City of Detroit
Inter-Departmental Communication

RE: Petition No. 541
Request to Outright Vacate The North/South In The Block Bound By Hamlet,
Buffalo, Bloom And Eight Mile Road

NOTICE OF PROPOSED CHANGE IN PROPERTY

OUTRIGHT VACATION
 THE NORTH/SOUTH PUBLIC ALLEY, 18 FT. WD.
 IN THE BLOCK BOUND BY
 HAMLET AVE., BUFFALO AVE., BLOOM AVE.
 AND E. EIGHT MILE ROAD

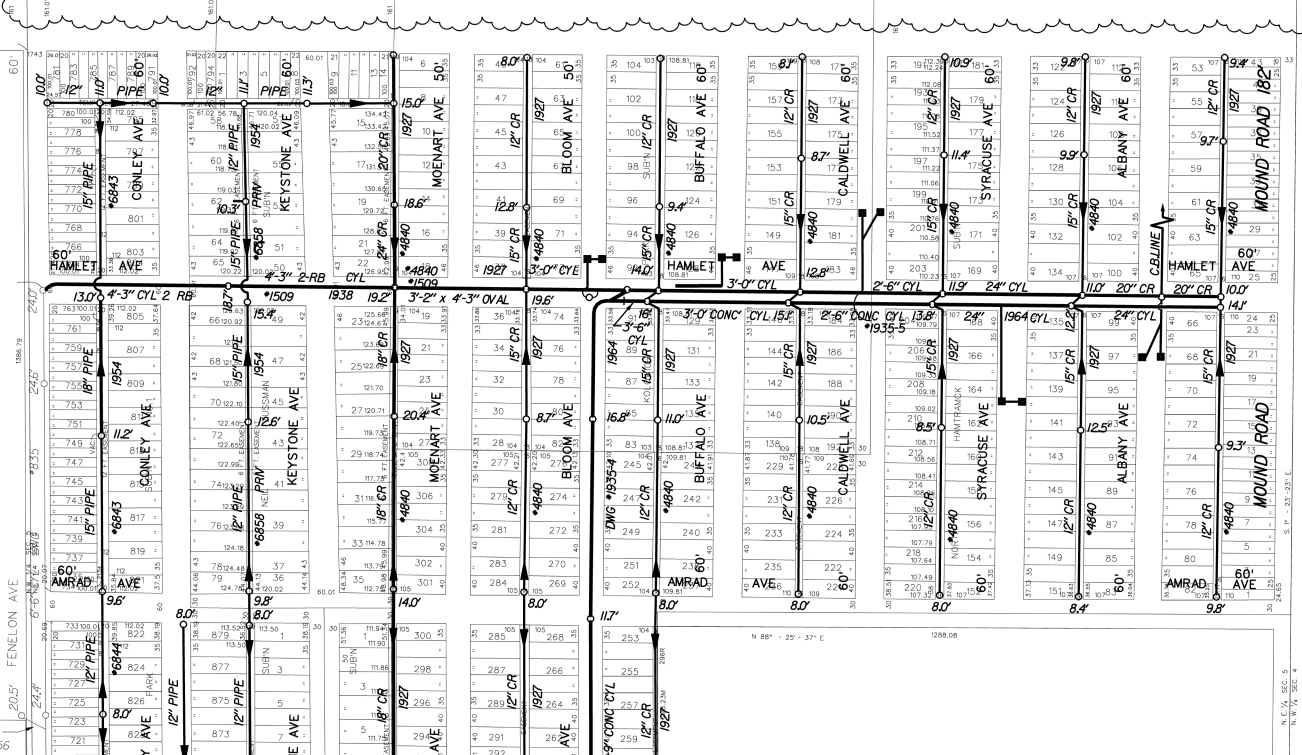
The Detroit Water and Sewerage Department (DWSD) is in receipt of the subject petition. DWSD has a sewer located within the area requested for outright vacation. DWSD has no objection to the requested vacation provided that the following conditions are met:

- The sewer services no other properties and only service the properties owned by the Petitioner, if not the Petitioner must prepare a relocation plan for the sewer signed by a Registered Engineer, DWSD approves the relocation plans, and the Petitioner grants a satisfactory easement for the relocated sewer. The Petitioner is to bear the entire cost of the proposed relocation plans, including construction, demolition, permitting, inspection, survey, etc.
- If DWSD is to maintain ownership of the existing sewer a satisfactory easement is to be granted by the Petitioner.

The entire work is to be performed in accordance with DWSD specifications and standards, all of the fees are to be deposited with DWSD in advance, to cover the necessary costs of permits and inspection.

Provided that the petitioner shall design and construct proposed sewers and to make the connections to the existing public sewers as required by the Detroit Water and Sewerage Department (DWSD) prior to construction of the proposed sewers,

Provided that the plans for the sewers shall be prepared by a registered engineer; and further

Provided that DWSD be and is hereby authorized to review the drawings for the proposed sewers and to issue permits for the construction of the sewers, and further

Provided that the entire work is to be performed in accordance with plans and specifications approved by DWSD and constructed under the inspection and approval of DWSD; and further

Provided that the entire cost of the proposed sewers construction, including inspection, survey and engineering shall be borne by the petitioner; and further

Provided that the petitioner shall deposit with DWSD, in advance of engineering, inspection and survey, such amounts as the department deems necessary to cover the costs of these services; and further

Provided that the petitioner shall grant to the City a satisfactory easement for the sewers; and further

Provided that the Board of Water Commissioners shall accept and execute the easement grant on behalf of the City; and further

Provided, that the petitioner shall provide DWSD with as -built drawings on the proposed sewers; and further

Provided that the petitioner shall provide a one (1) year warranty for the proposed sewers; and further

Provided that upon satisfactory completion, the sewers shall become City property and become part of the City system. And any existing sewers that were abandoned shall belong to the petitioner and will no longer be the responsibility of the City.
